ecgine at the Copy to Appropriate District: 22 A	State of New Mexico	Form C-103
Office <u>District I</u> – (575) 393-6161	Energy, Minerals and Natural Resources	Revised July 18, 2013
1625 N. French Dr., Hobbs, NM 88240		WELL API NO.
<u>District II</u> – (575) 748-1283	OIL CONSERVATION DIVISION	30-015-55143
811 S. First St., Artesia, NM 88210		5. Indicate Type of Lease
<u>District III</u> – (505) 334-6178 1000 Rio Brazos Rd., Aztec, NM 87410	1220 South St. Francis Dr.	STATE STATE STATE
District IV – (505) 476-3460	Santa Fe, NM 87505	6. State Oil & Gas Lease No.
1220 S. St. Francis Dr., Santa Fe, NM		
87505		
	ES AND REPORTS ON WELLS	7. Lease Name or Unit Agreement Name
	LS TO DRILL OR TO DEEPEN OR PLUG BACK TO A	
PROPOSALS.)	TION FOR PERMIT" (FORM C-101) FOR SUCH	BARNEY
	as Well 🛛 Other	8. Well Number

-		223H
2. Name of Operator		9. OGRID Number
Permian Resources Operating LLC		372165
3. Address of Operator		10. Pool name or Wildcat
300 N Marienfeld St Ste 1000		Purple Sagel Wolfcamp (Gas)

WELL LOCATION AND ACREAGE DEDICATION PLAT

Permian Resources - Barney 223H

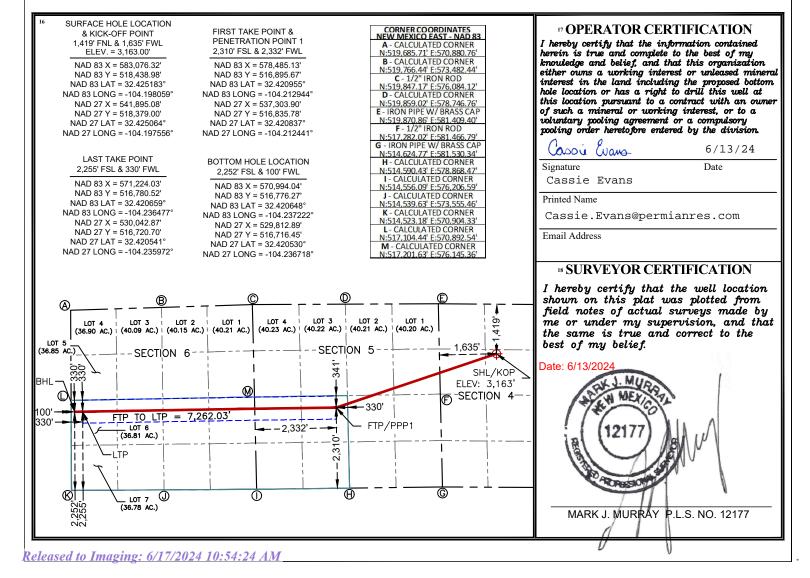
d according to the attached drilling plan. We will dr	fill a 8.75° Hole from $0 - 10419$ ° and then a
7.875 hole from 10419' – 17852'.		
G		
Spacing Changes:		
		a
LTP FROM: 2310' FSL, 100' FWL Se	c 6, T22S, R27E TO: 2252' FSL, 100' FWL	Sec 6, T22S, R27E
BHL FROM: 2310' FSL, 100' FWL Se	ec 6, T22S, R27E TO: 2252' FSL, 100' FWL	Sec 6, T22S, R27E
Spud Date:		
	Rig Release Date:	
	Rig Release Date:	
L	Rig Release Date:	
L hereby certify that the information ab-		ve and belief
I hereby certify that the information about	Rig Release Date:	ge and belief.
I hereby certify that the information about		ge and belief.
	ove is true and complete to the best of my knowledge	
I hereby certify that the information about SIGNATURE_	ove is true and complete to the best of my knowledge	pe and belief.
SIGNATURE	ove is true and complete to the best of my knowledg	DATE6/13/24
SIGNATURE Type or print name <u>Cassie Evans</u>	ove is true and complete to the best of my knowledge	DATE6/13/24
